Office Action Summary	Application No. 10/599,888	Applicant(s) FEIGL, ANDREAS	
	Examiner KRISTINA R. FULTON	Art Unit 3673

DETAILED ACTION

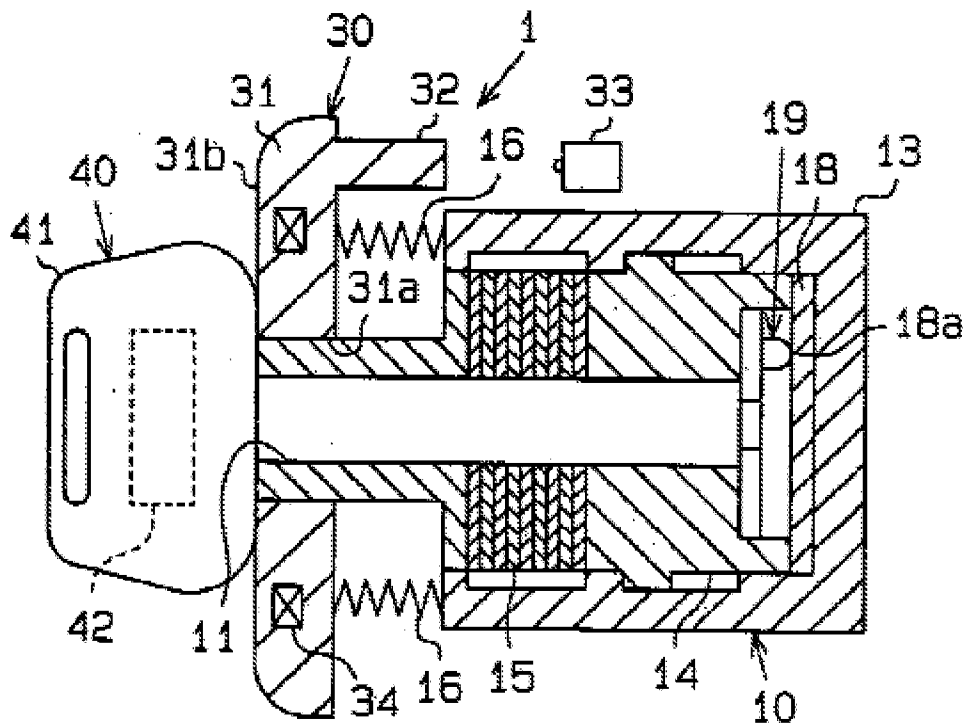
6. Regarding claims 1, 7, Ohtaki shows an actuating module for a motor vehicle, comprising a housing (21); a movably-supported actuation component (22, 31) within a frontal opening of the housing, which can be moved manually by means of a front actuation surface serving as a grip element against an opposing force (26) from a rest position into the housing, and after activation of at least one operating switch (33) for a corresponding operating function returns to its rest position; wherein the actuation component comprises a slot (11) for insertion of an electronic identification device (40) and the actuation component can also be moved without the identification device being inserted (paragraph [0037]), and wherein the actuation component consists of two part components which fit inside each other, of which one has the slot for the identification device and is mechanically coupled with the other subcomponent embodied as a switching component such that the other part component can be moved independently of the one part component by means of the actuation surface serving as a grip element (paragraph [0059]).

7. Regarding claims 2, 8 and 14 the at least one operating switch can be switched by each of the two subcomponents (paragraph [0055]; line 17 and paragraph [0067]).

8. Regarding claims 3, 9 and 15 different operating switches can be switched with the two subcomponents (paragraph [0074]).

12. Claim 13 is rejected as applied to claims 1 and 5 above. See the Ohtaki device below.
